Addendum #1

Project: MILWAUKEE PUBLIC LIBRARY GOOD HOPE MILL ROAD

From: Zimmerman Architectural Studios, Inc.

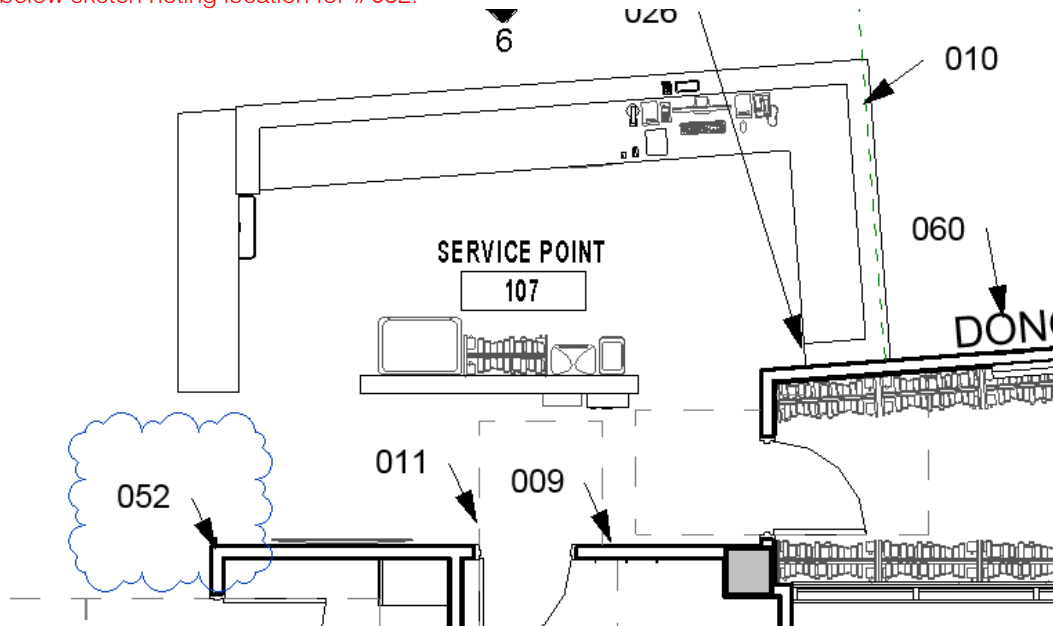
1. On the Proposal Breakdown Sheet, under the code list, there is a Type "I" for "Hostess Cart" on the form. Type "I" on the Sign Schedule is "Evacuation Plan" (Qty= 4). However, there is no Type I shown in the sign type drawings. Can you please provide sign type detail?
 - a. If Type I is an evacuation plan sign, will bidders be responsible for creating each evac map (with egress route, graphic symbols, etc)?

ZAS Response: Egress signage now included in bid package. Bidders responsible to creating each evac map with routes, graphic symbols. Etc.
